# Addendum No. 1

## Donner Dam Repairs

TMWA Bid No. 2016-006  
October 8, 2015

**A** PLAN VIEW AT FISH LADDER  
N.T.S.

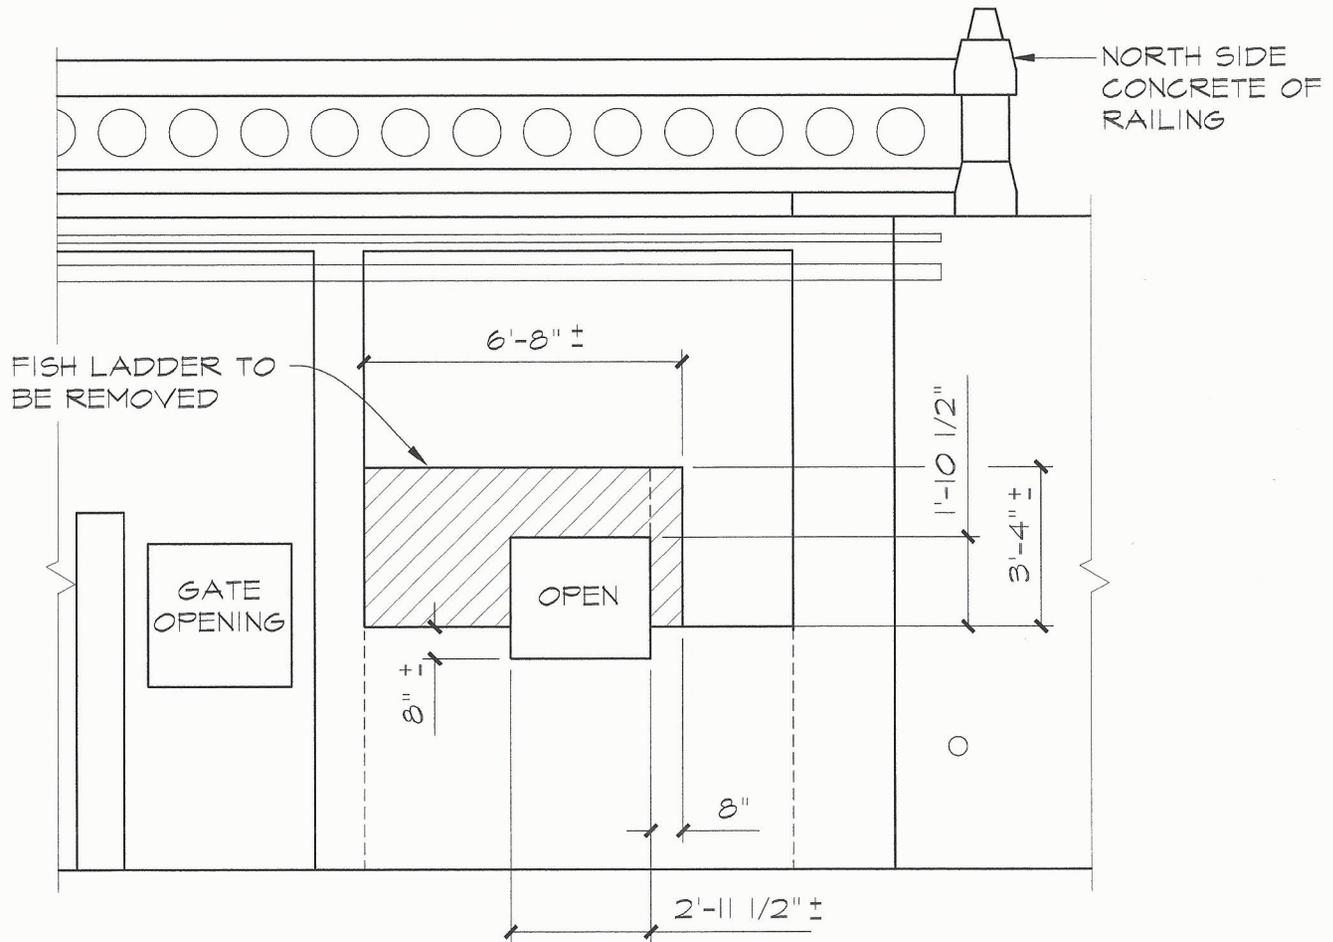
4. **Question No. 4:** Are there any as built drawings or original design drawings for this dam that would give the dimensions for the fish ladder that is to be removed so that we know how much concrete we will be removing on this item? It is not in a condition that we can access the location to measure for our calculation for pricing the removal and disposal of the fish ladder.

**Response to Question No. 4:** See attached drawings providing approximate dimensions for the existing fish ladder (**See Attachments**).
